# Recall Bulletin

## FMVSS NONCOMPLIANCE RECALL

**SUBJECT:** Occupant Crash Protection Compliance – Unbelted Passenger

**MODELS:** 2009-2010 Cadillac CTS All Wheel Drive  
 2009-2010 Cadillac CTS-V

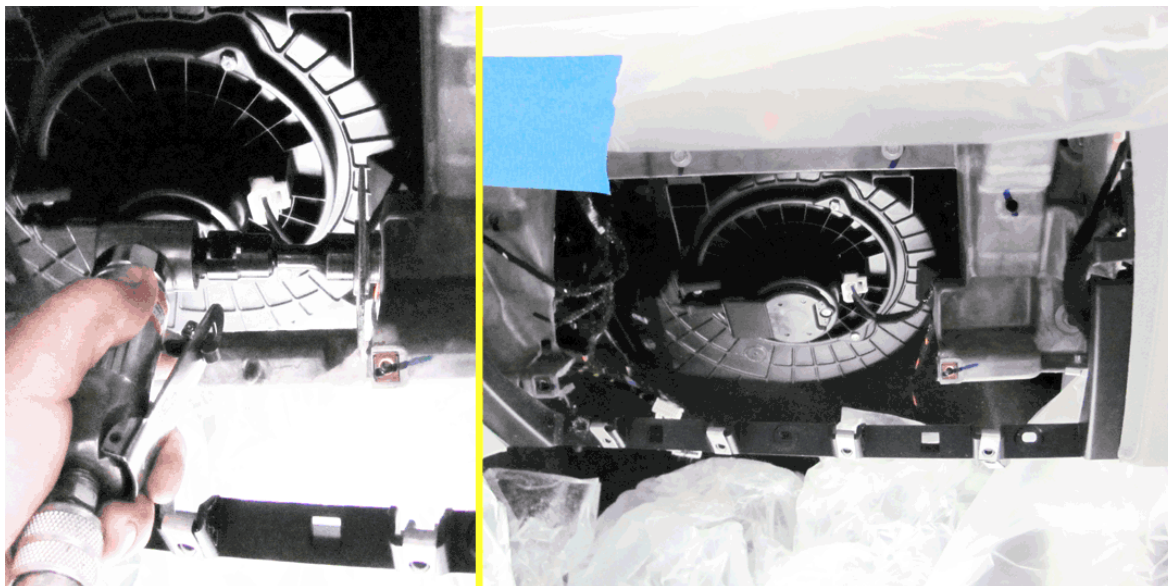
- 9.3 Using a pen, mark a cut line on the inboard side of the end cinch nuts (1). Refer to the illustration. The cut lines should be as close to the cinch nuts as possible.
- 9.4 Ensure that the instrument panel plastic retainer (4) is separated from the magnesium beam (3).

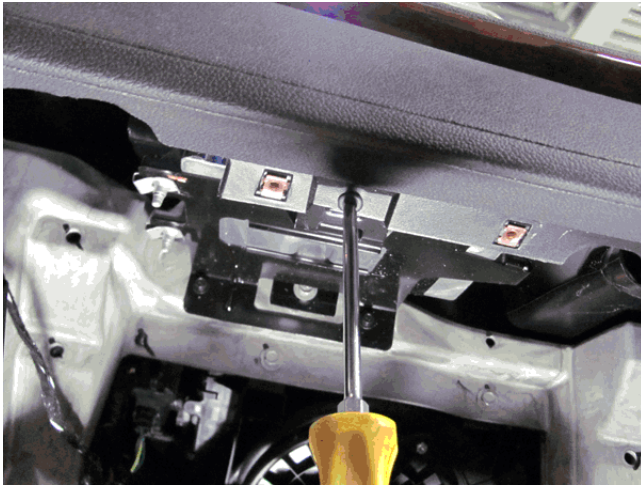
**Caution: Do NOT damage the end cinch nuts (1) while cutting the center section of the magnesium beam. The end cinch nuts are required to secure the instrument panel compartment assembly.**

- 9.5 Cut and remove the center portion of the lower magnesium beam (3) using a cut-off wheel, Dremel tool, or equivalent. A picture after the removal of the center portion of the lower magnesium beam is shown above.

## Right Hand Side Instrument Panel Plastic Retainer Cut Procedure

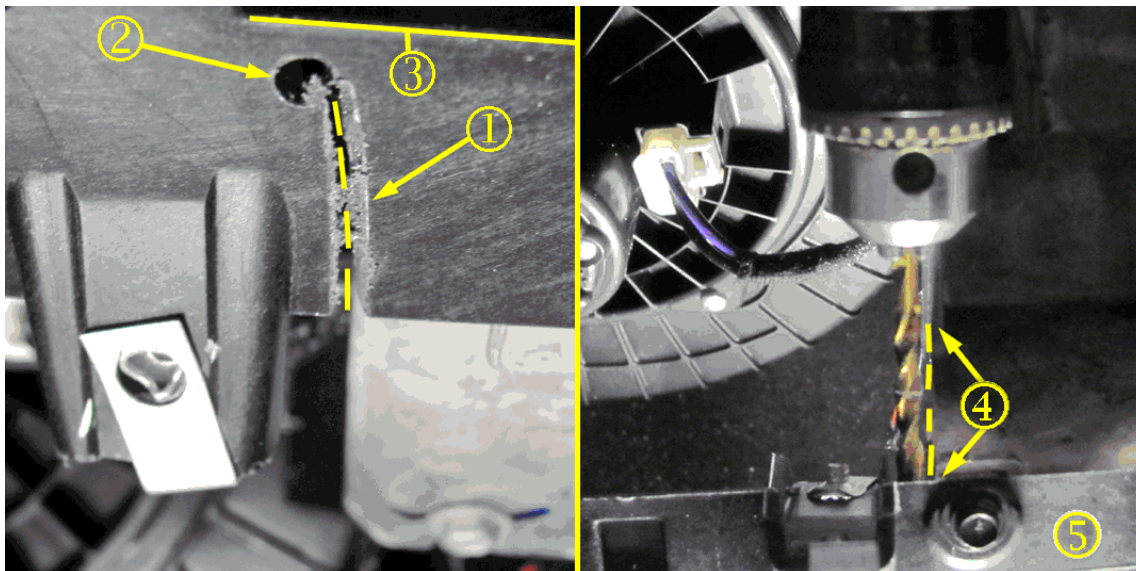
**Note:** The cut line should follow the edge of the outboard passenger side magnesium beam cut made in Step 9.5. Refer to *Outboard Passenger Side Lower Magnesium Beam Cut Completed* in the Step 9.5 illustration. Callout 2 shows the pre-drill of the outboard passenger side cut. End the cut line 1-2 mm (3/64-5/64 in) before the front face (5) surface edge (3) of the instrument panel plastic retainer.

15. Using a pen, mark a cut line (1) on the underside of the instrument panel plastic retainer along the outboard passenger side magnesium beam cut.

16. Drill a hole at the end point of the cut line using a 4.74 mm (3/16 in) drill bit. Drill the hole from the top of the instrument panel plastic retainer as shown in illustration.
17. Cut the underside of the instrument panel plastic retainer to the hole made in step 16.

#### Instrument Panel Insulator Screw Hole Cut Procedure

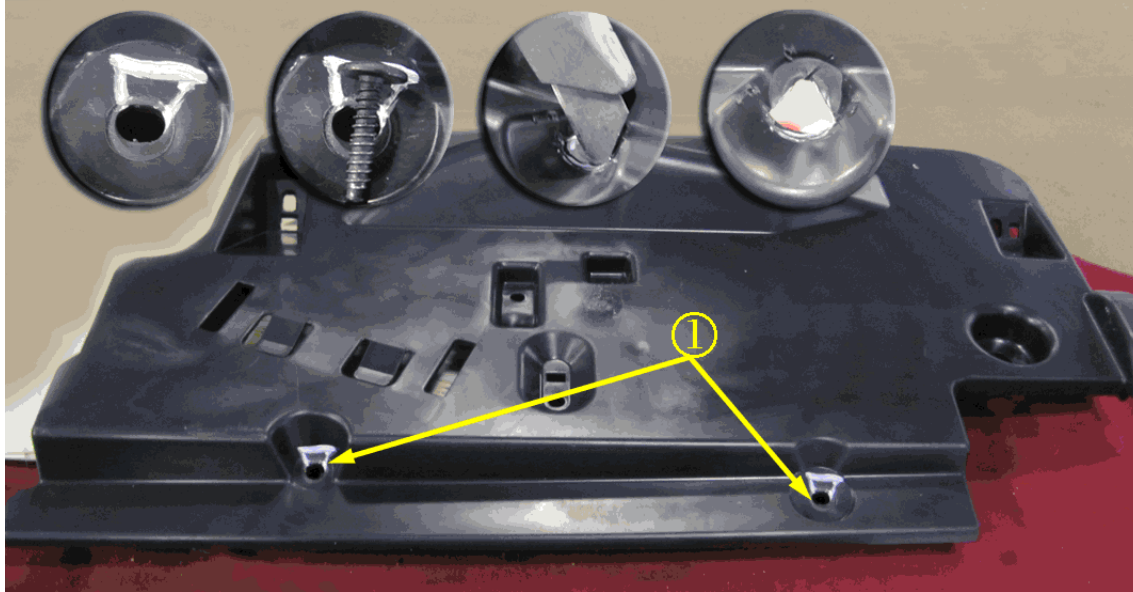
18. Modify the two instrument panel insulator screw holes (1). Refer to illustration.
  - 18.1 Using a pen, mark an 11 o'clock to 2 o'clock notch into the two screw holes. The notches should be slightly larger than the head of the screws.
  - 18.2 Using a box cutter (or equivalent tool) cut out the notched area of the screw holes.
19. Remove the plastic cover or drop cloth from the passenger side of vehicle. Clean the remaining debris from the interior.

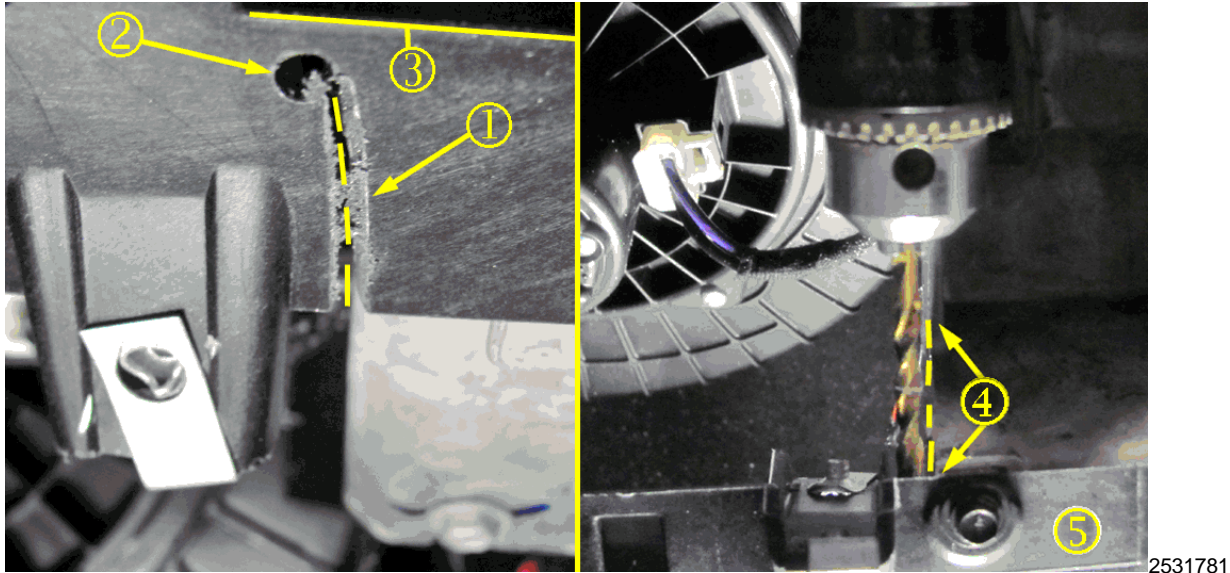
**Callouts (1), (2) (3) show cut out portions of the second design magnesium beam.**

6. Follow the production outboard passenger side cutout (3). Refer to the illustration. End the cut line 1-2 mm (3/64-5/64 in) before the front face (5) surface edge (3) of the instrument panel plastic retainer. Remove the three instrument panel plastic retainer screws to view the production outboard passenger side cutout (3). Re-install the screws after viewing the cutout.

7. Drill a hole (2) at the end point of the cut line (1) using a 4.74 mm (3/16 in) drill bit. Drill the hole from the top of the instrument panel plastic retainer (4) as shown in illustration.
8. Cut the underside of the magnesium beam (1) retainer to the hole (2) made in Step 7.

### Instrument Panel Insulator Screw Hole Cut Procedure

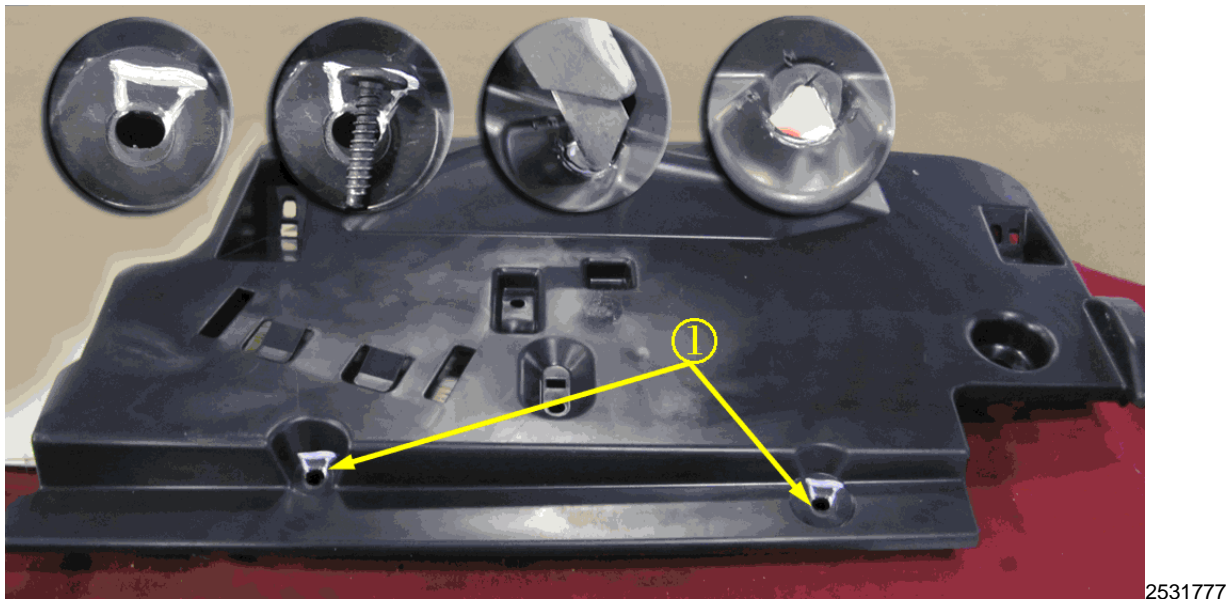
9. Modify the two instrument panel insulator screw holes (1). Refer to the illustration.
  - 9.1 Using a pen, mark an 11 o'clock to 2 o'clock notch into the two screw holes. The notches should be slightly larger than the head of the screws.
  - 9.2 Using a box cutter (or equivalent tool), cut out the notched area of the screw holes.
